FROM: AMHI Center Building Storage Addendum 2
TO: Prospective Bidders, Suppliers, and Other Parties
RE: Addendum No. **2 (Two)** to the Bidding Documents

AMHI Center Building Storage, Augusta ME

ADDENDUM 02 - 10.27.2021

S-000

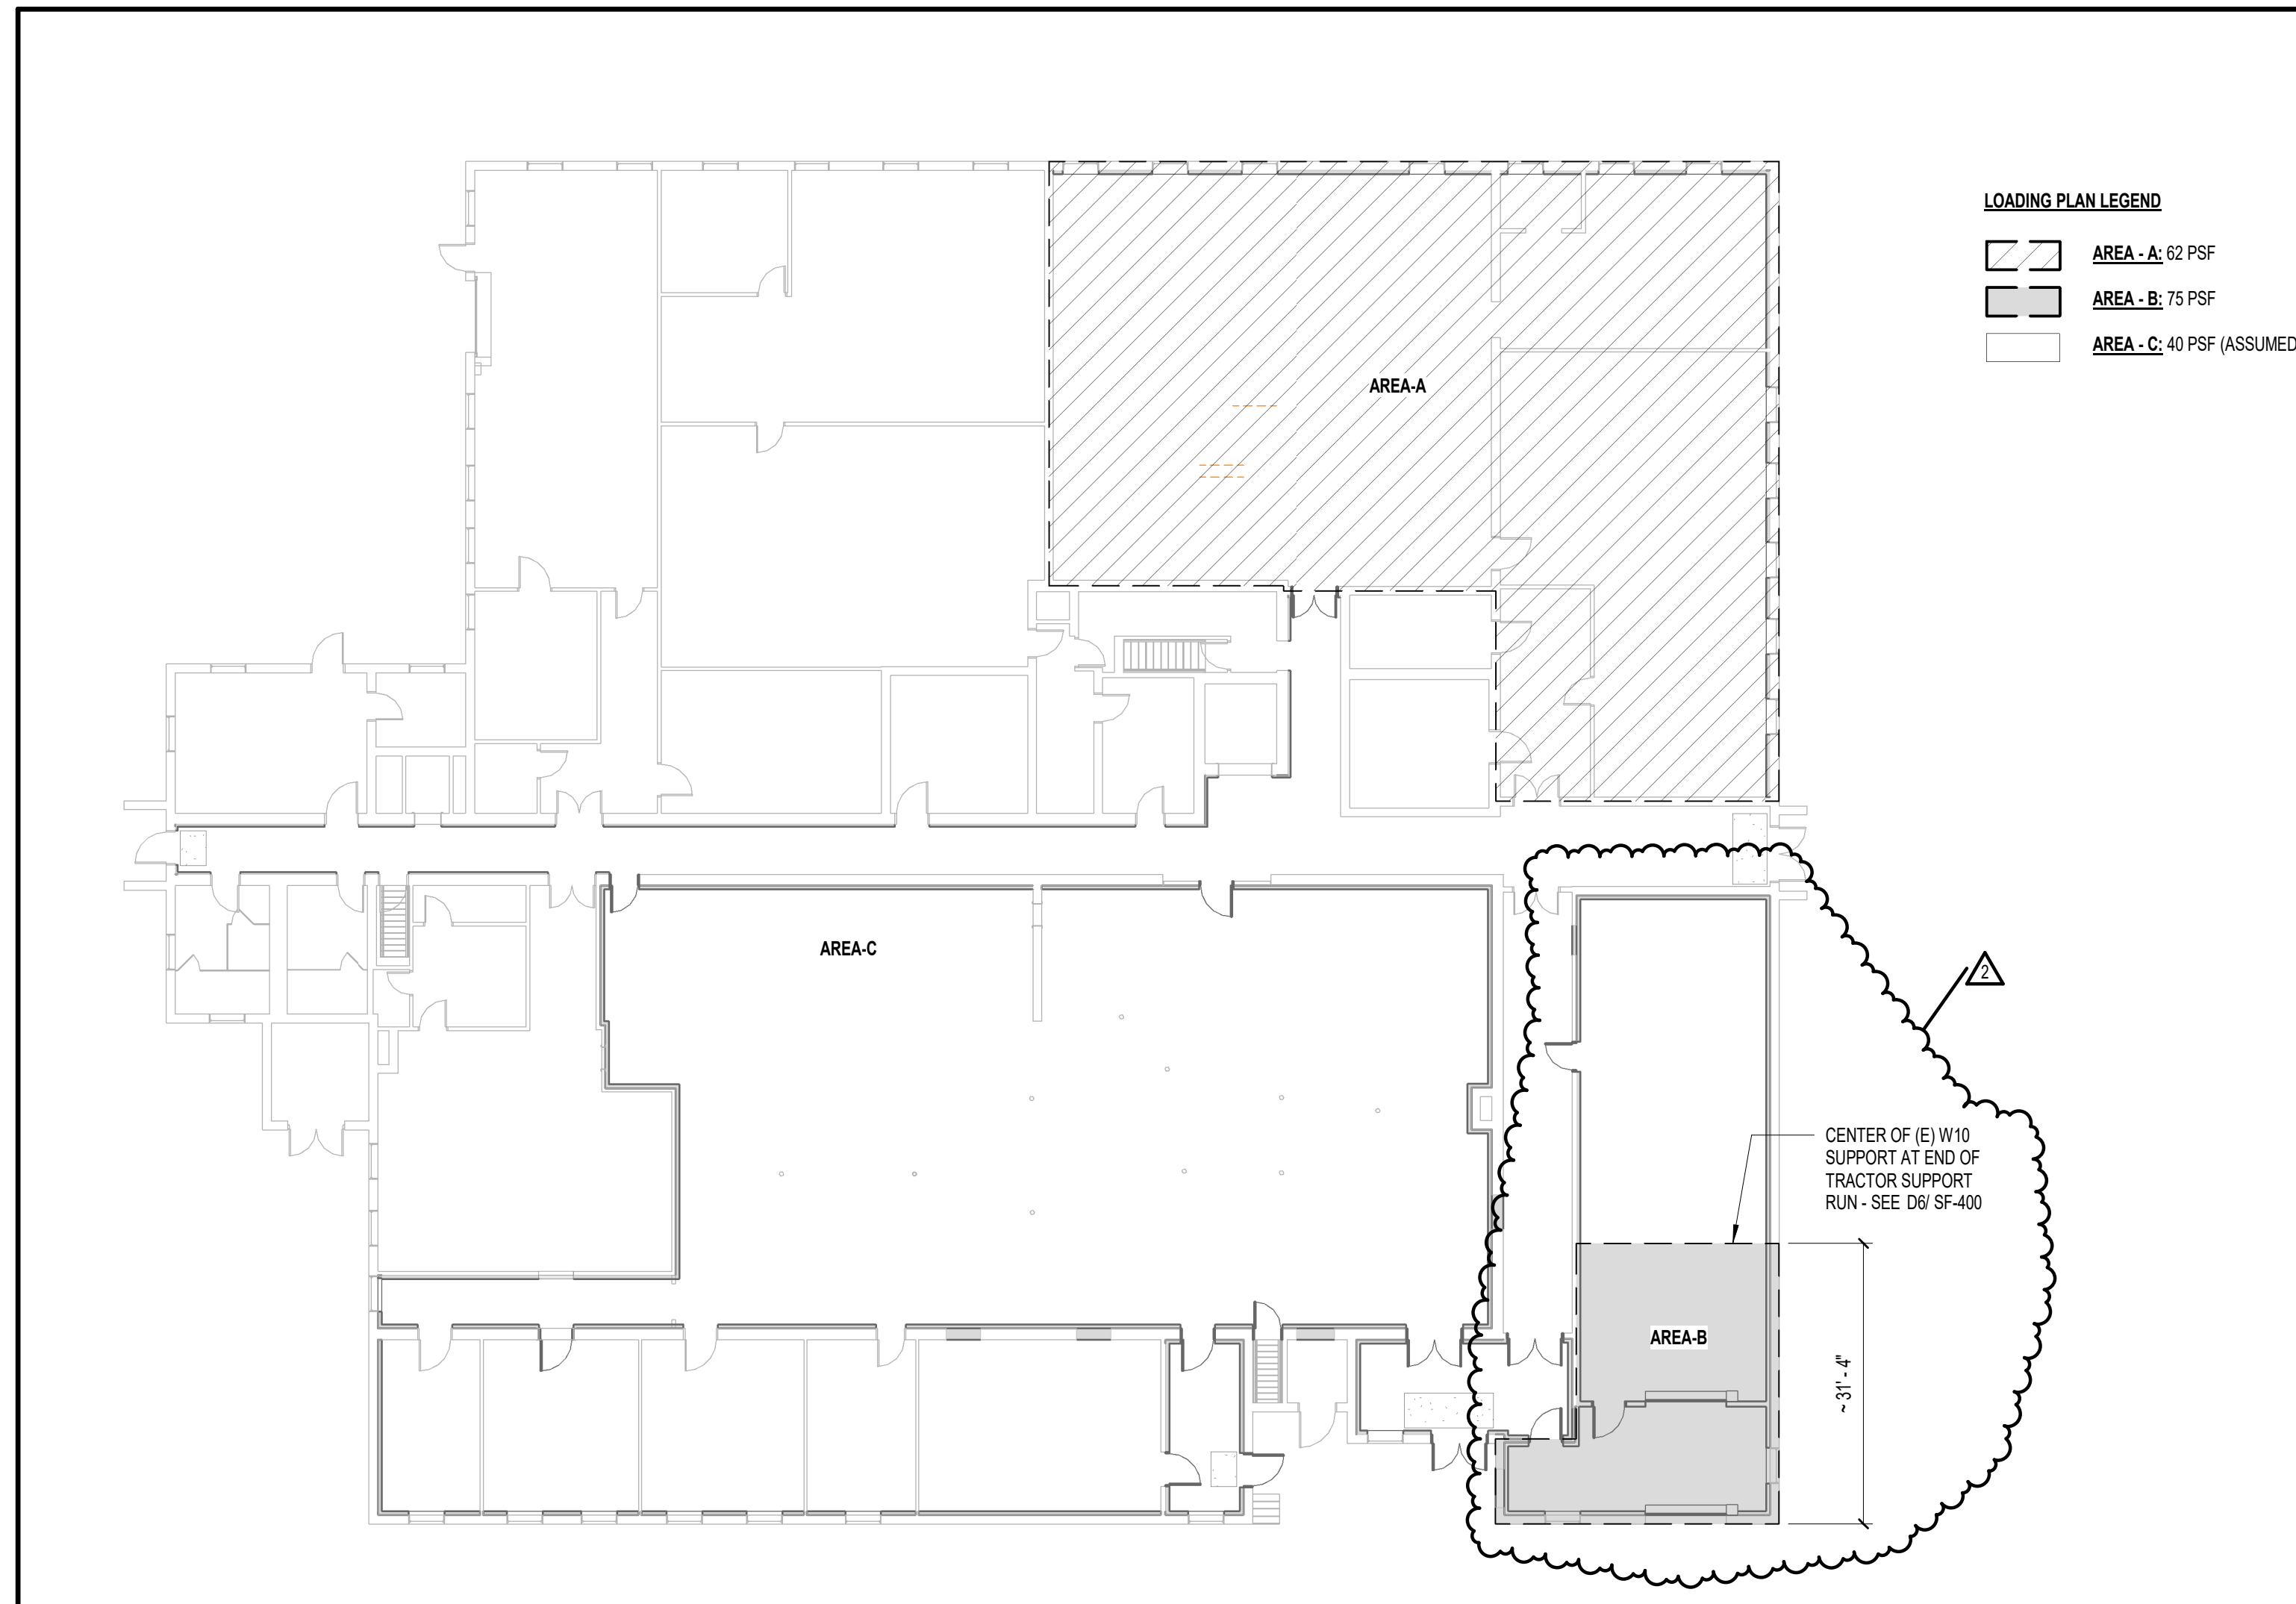
1. **SHEET G-000**– **ADDED** sheet SF-400 – STRUCTURAL-ENLARGED FRAMING PLAN AND DETAILS
2. **SHEET AD1.13**– **MOVED** Overhead door moved 16” west
3. **SHEET A1.13** – **MOVED** Overhead door moved 16” west
4. **SHEET A2.13**– **MOVED** Overhead door moved 16” west
5. **SHEET S-000** – **ADJUSTED** limit of AREA-B loading
6. **SHEET SF-100** – **ADJUSTED** Limit of tractor travel, **ADDED** enlarged plan D6/SF-400
7. **SHEET SF-110** – **REPLACED** Note 1 of the ROOF AND EXTERIOR FAÇADE CONDITIONS
8. **SHEET SF-200** – **REPLACED** Note 1 of the ROOF AND EXTERIOR FAÇADE CONDITIONS
9. **SHEET SF-201** – **REPLACED** Note 1 of the ROOF AND EXTERIOR FAÇADE CONDITIONS
10. **SHEET SF-400** – **ADDED** Sheet in its entirety

SF-200

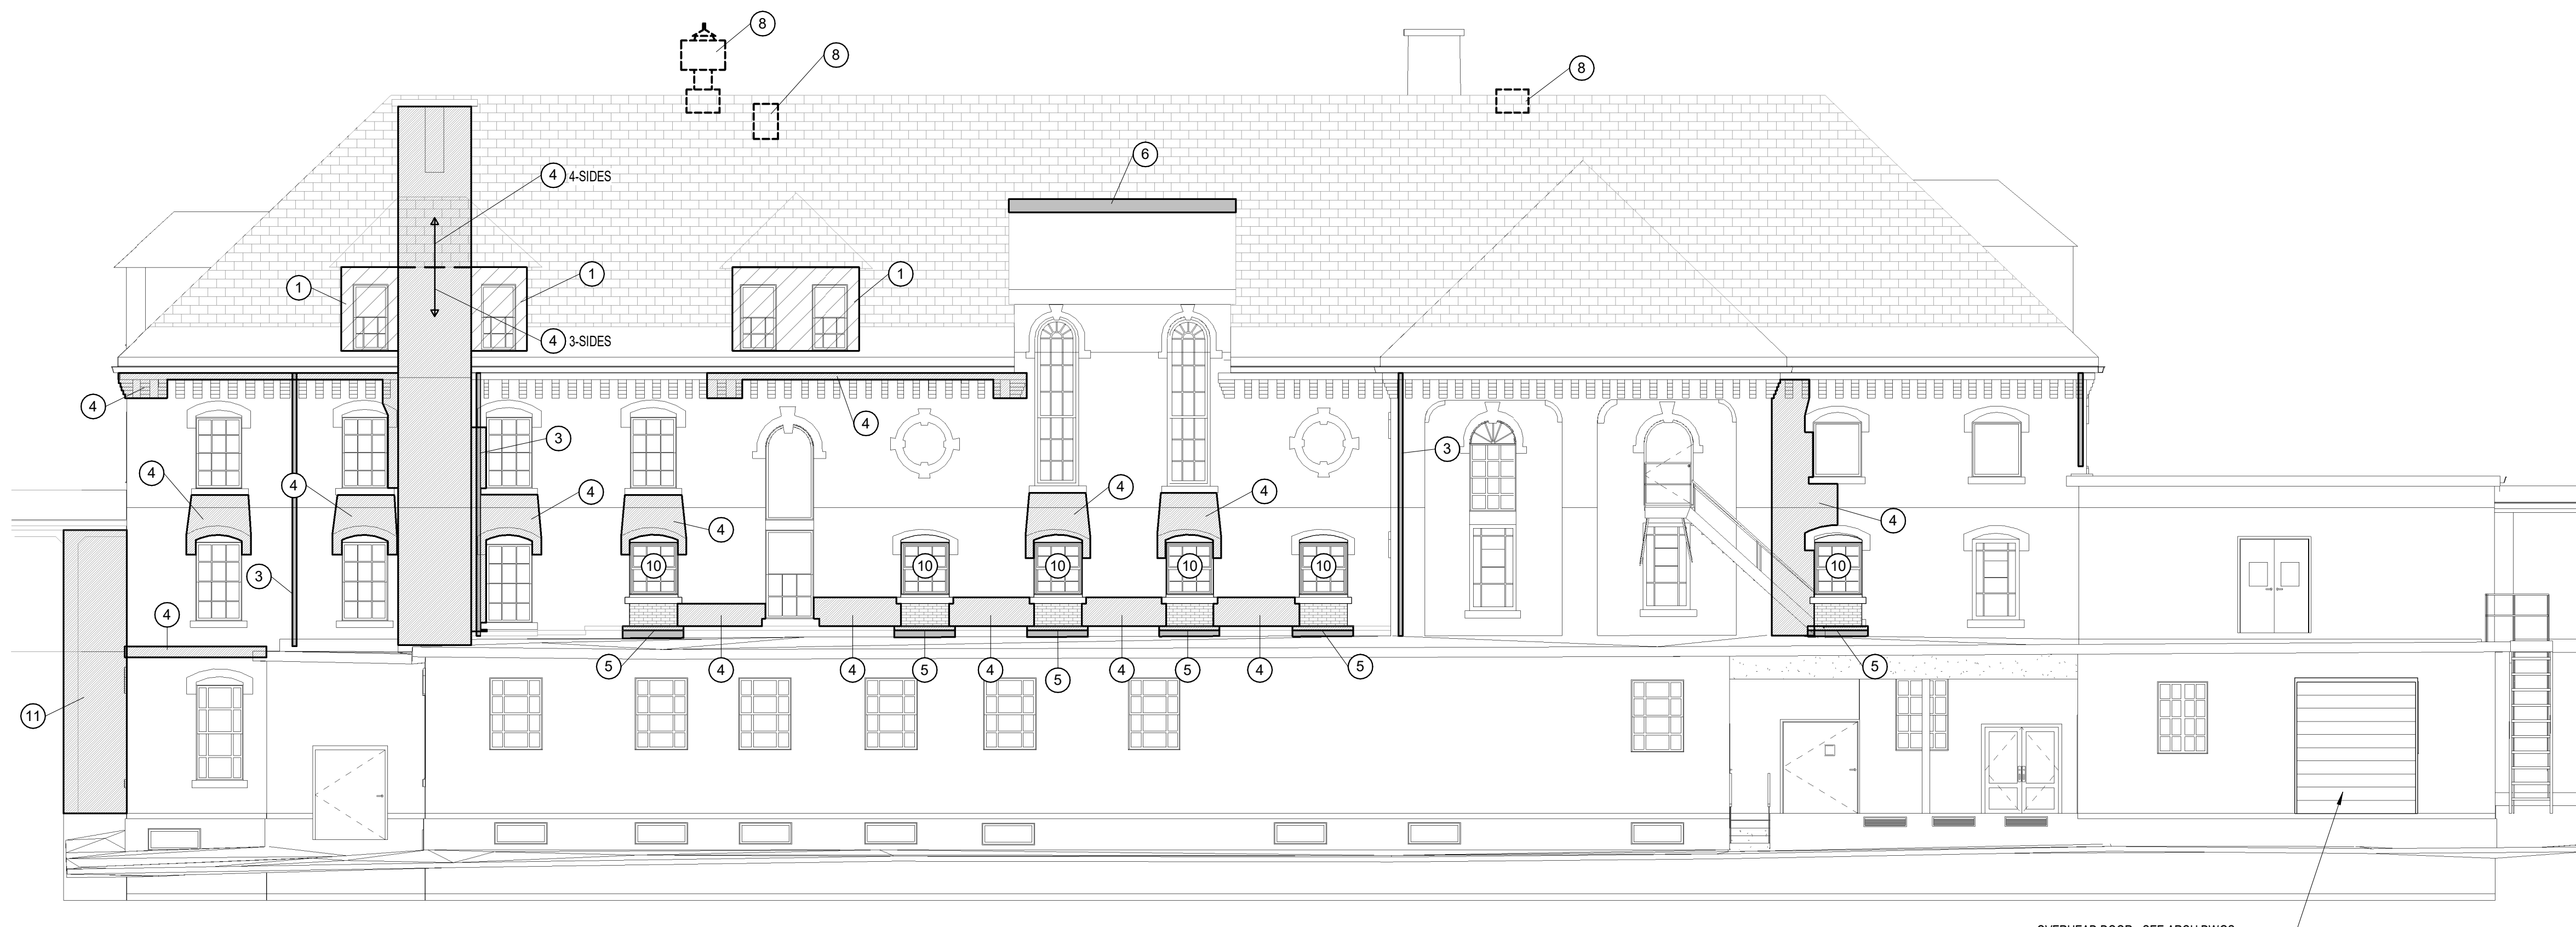
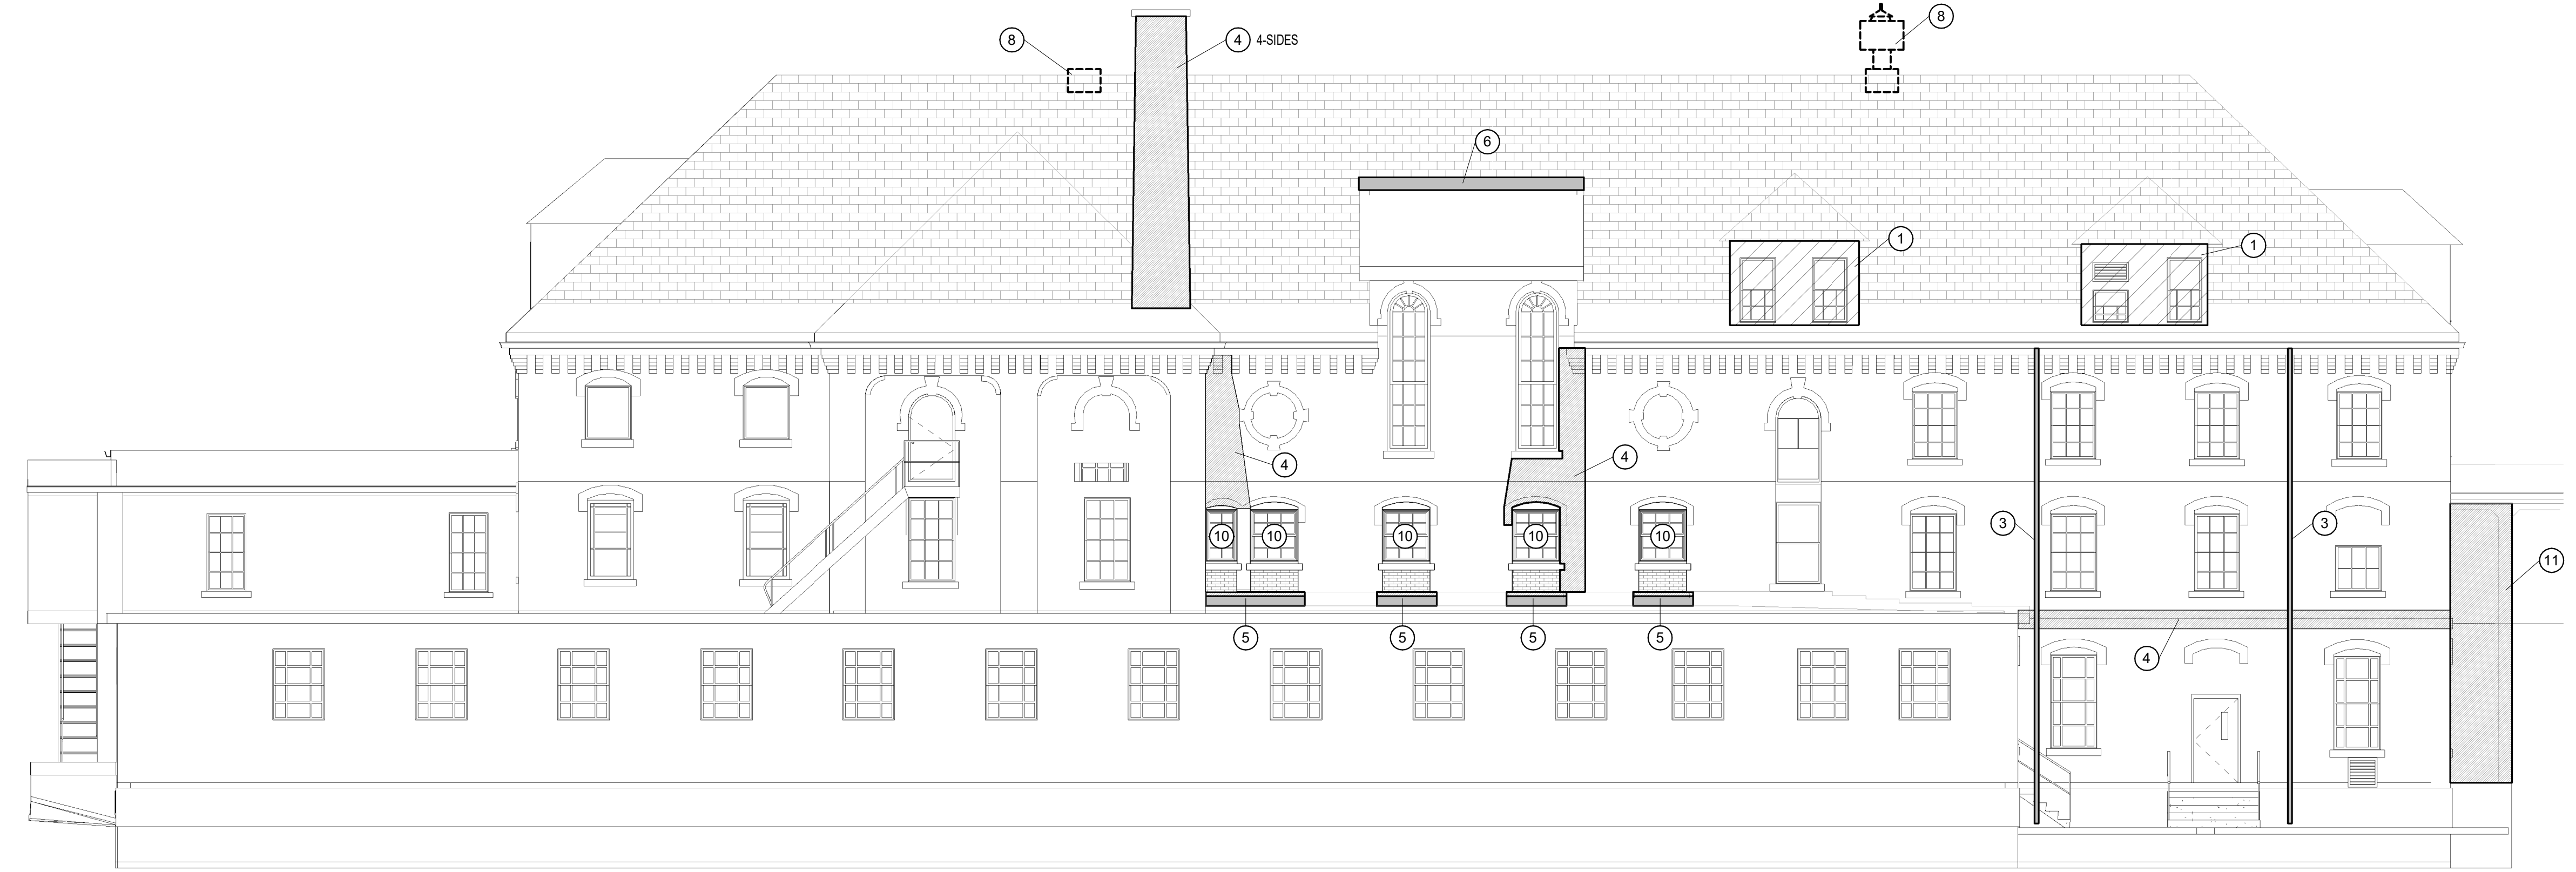
5	PC Construction			Please confirm the Contractor is responsible to provide builder's risk insurance for the Work itself?	AEI: that is correct.
6	PC Construction			Please confirm that the Owner will maintain property insurance on the existing State-owned buildings and that Owner shall be responsible for all deductibles associated with losses to the existing State-owned buildings?	AEI: that is correct.
7	PC Construction			Please note section E1 on Drawing SF-500. Please provide a TOC or TOS elevation for both the lower and first floor level. [PED]	AEI: Basement slab to first floor slab = ~ 8'-6".
8	PC Construction			Please note Allowance item 1: Replace Wood Trim and Siding at Dormers Noted on Contract Documents (Masonry note 1, Sheet SF-110, SF-200 and SF-201). This allowance is listed on the bid form as a Lump Sum Unit, with a quantity of one. The drawings as noted in the allowance item, shade the areas of work where the allowance shall be applied, however they lack sufficient detail needed to accurately price the work that is required to be performed: dimensions, siding & trim materials, details, etc. To make the bid comparison's accurate, we feel that the Owner and A/E should provide an allowance amount for this bid item, which would be carried by all the bidders. The same consideration could be applied to each of the lump sum allowances (numbers 3 and 5).	AEI: See Sheets SF-200 and SF-201 for revised Note 1 of the ROOF AND EXTERIOR FAÇADE CONDITIONS.

9	PC Construction			Please note drawings A3.01, A3.02, SF -200 and SF-201. To accurately determine means and methods to access the exterior of the building, the levels of each floor would be helpful. Please provide elevations for each of the floor levels of the building.	AEI: Basement level ~ (-)8'-6", First Floor Level ~ 0'-0", Second Flr level / low roof ~ 12' cave height at upper roof ~ 37'-0" above 1st floor level. Contractor is required to field veri these elevations.
10	Blaine Casey Construction			The Architectural plans provided do not include any cross sections of the areas to be renovated or any elevations marked with floor/wall heights other than for the Loading Dock area as shown at E5/A303. Are all of the wall heights in the areas to be renovated similar to what is shown there (13'-1½" Floor to Floor). The only cross section I could see in the Structural Plans was at E1/SF-500. This detail shows a height from 1st Floor slab to the bottom of the 2nd Floor fluted slab above of 8'. Please provide more details regarding the wall heights.	CWS: For pricing purposes, the finish floor to underside of deck height within the northern half of the overall plan is 12'-6". The finish floor to underside of deck height within the southern half of the overall plan is 13'-8".

- ① THE GABLE DORMERS FAÇADE IS SIDED WITH A WOOD TRIM AND WOOD PANEL INSERTS. THE WOOD TRIM WRAPS THE SIDES AND TERMINATES AT THE COPPER SKIRT FLASHING. IT IS THE PROJECT'S INTENT TO REMOVE AND REPLACE ALL EXISTING WOOD TRIM AND SIDING AT THE DORMER LOCATIONS INDICATED.
